DESCRIPTION OF PROPOSED CHANGE NDF-10-51 AND SAFETY ANALYSIS  
AMENDMENT APPLICATION NO.15 , OPERATING LICENSE NPF-10

This is a request to make various editorial changes in Appendix A, Technical Specifications.

Figure 3.4-2

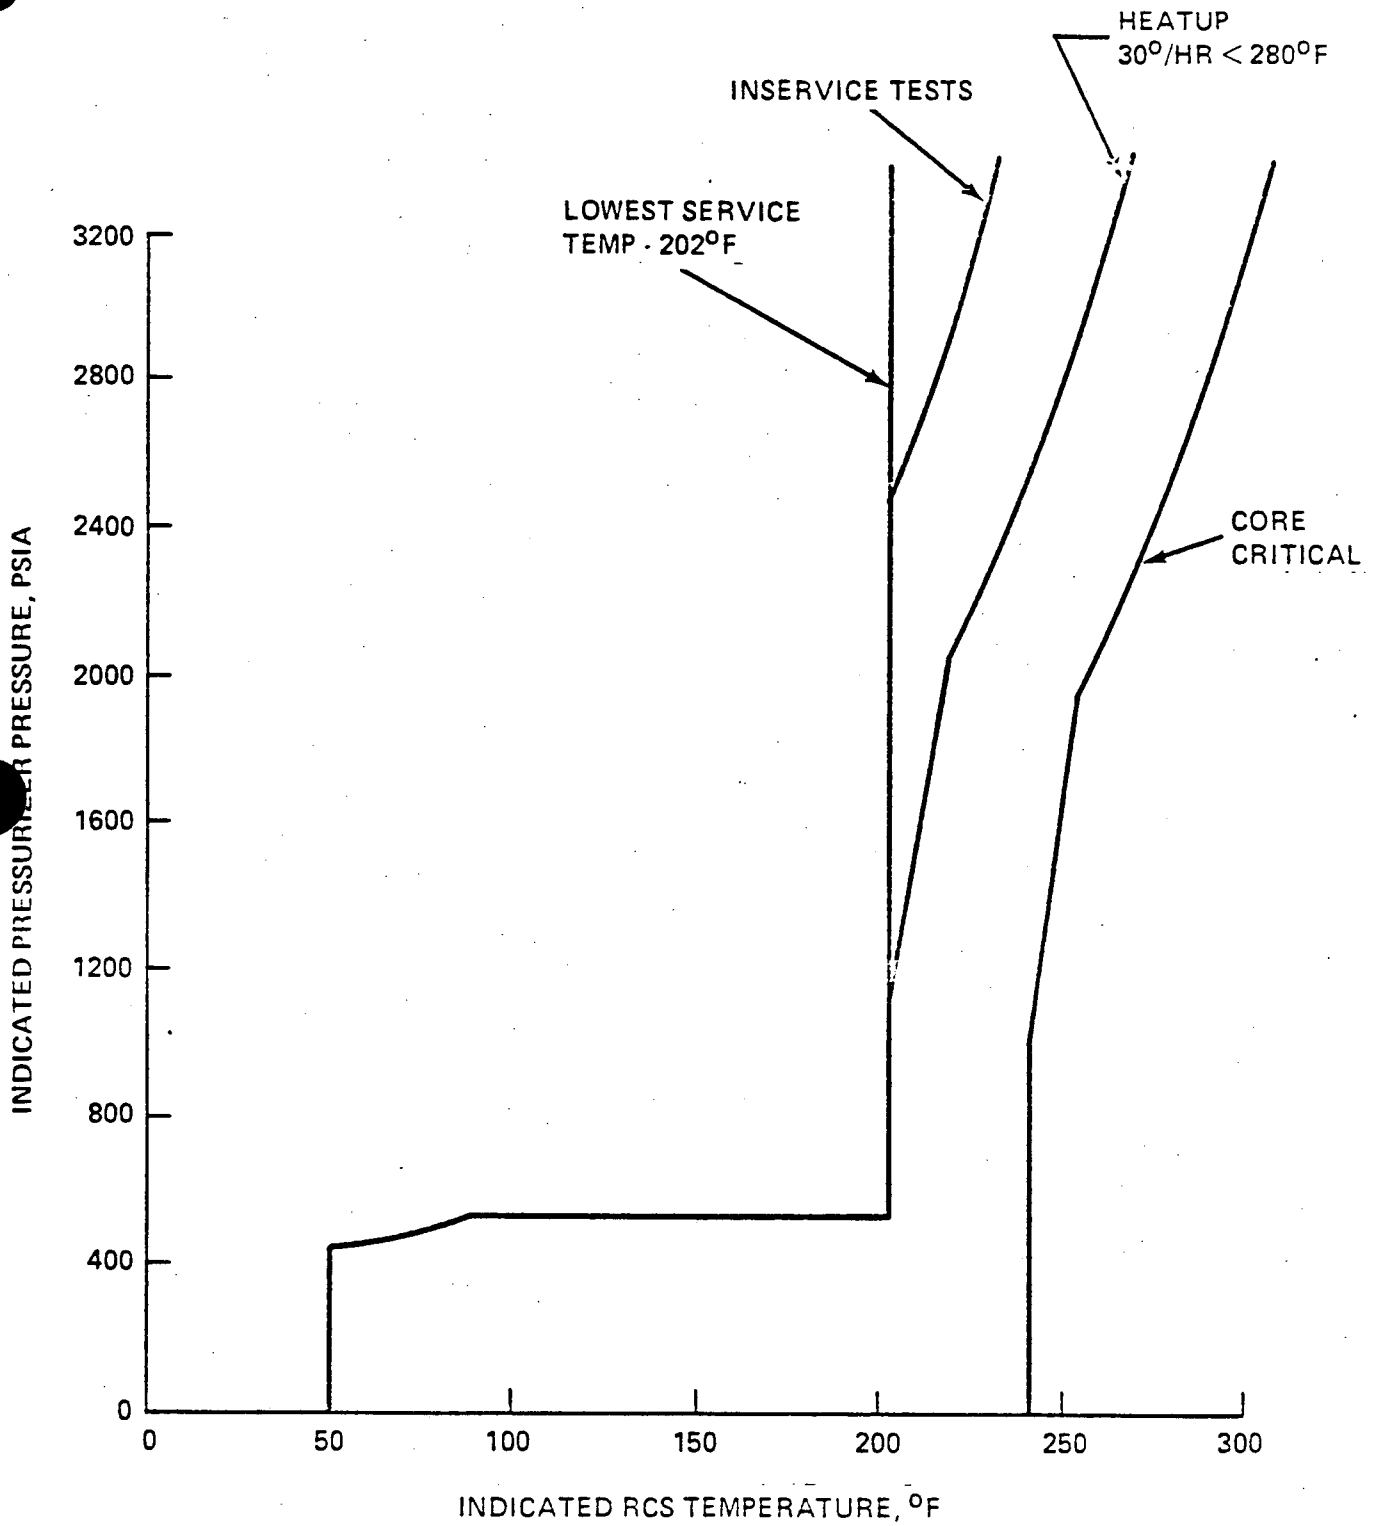
3/5 4-29 Change title of Figure 3.4-2 to all CAPS and delete ": SCE 11" from title.

Figure 3.4-3

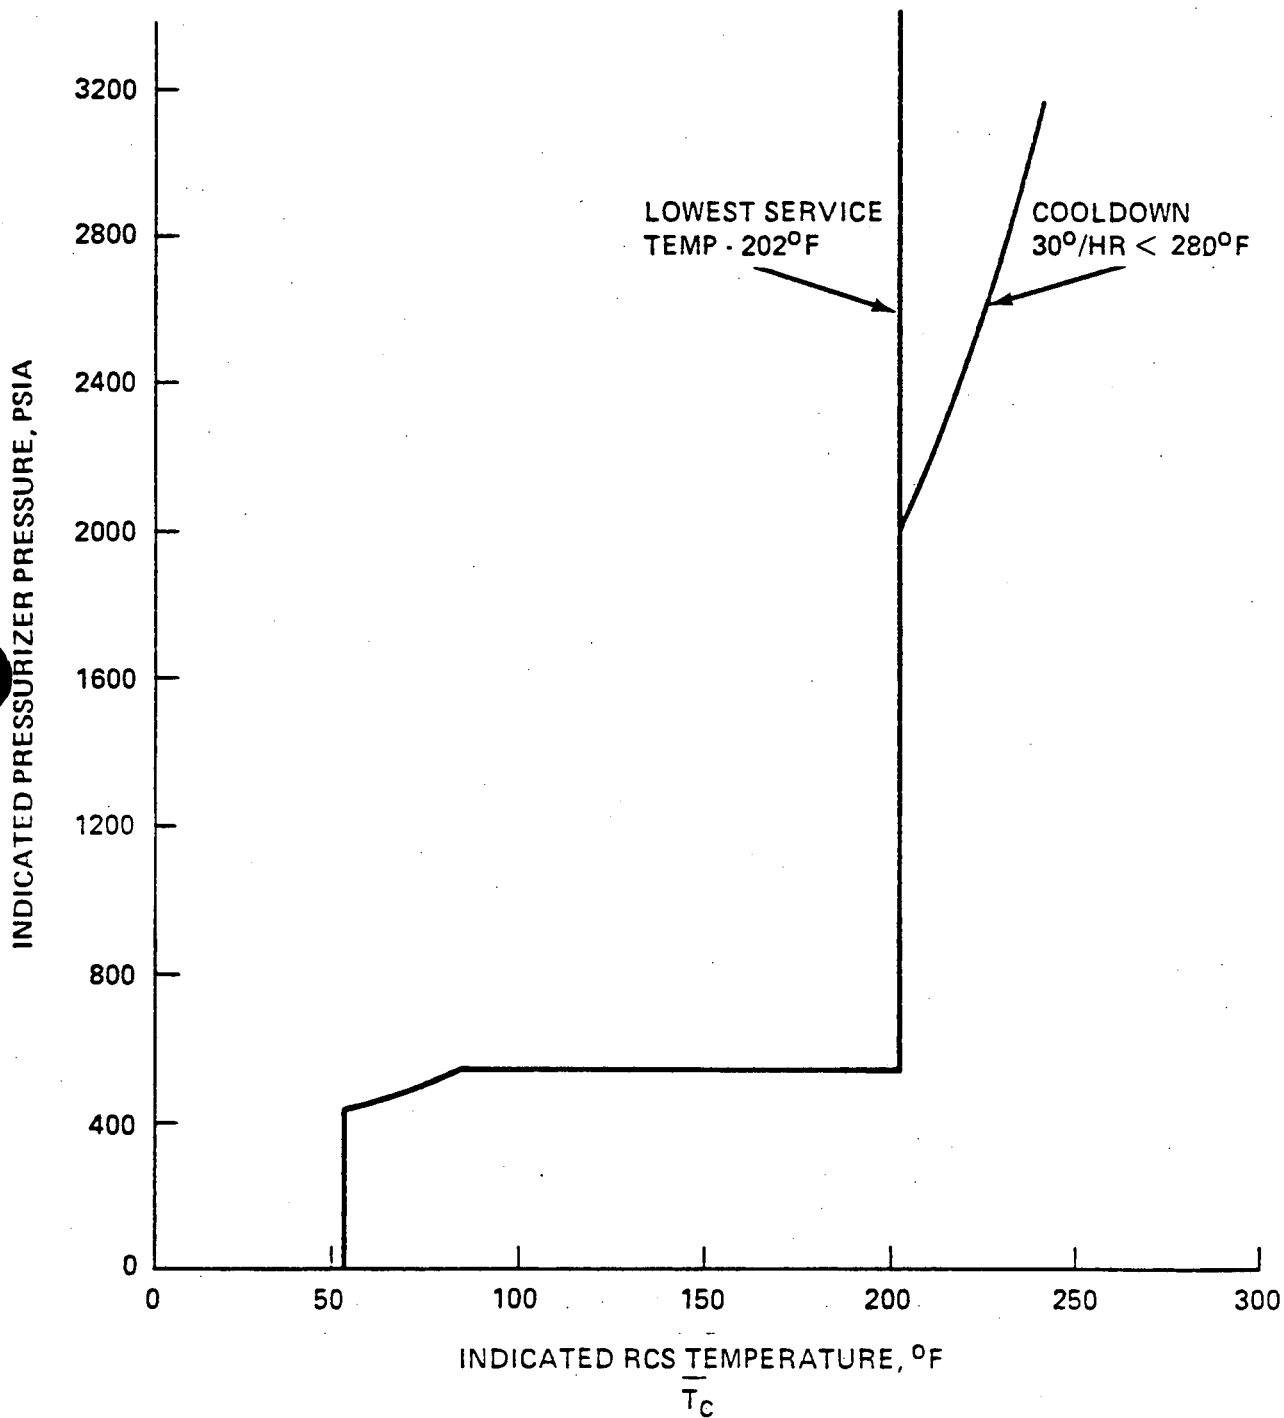
3/4 4-30 Change title of Figure 3.4-3 to all CAPS and delete ": SCE 11" from title,
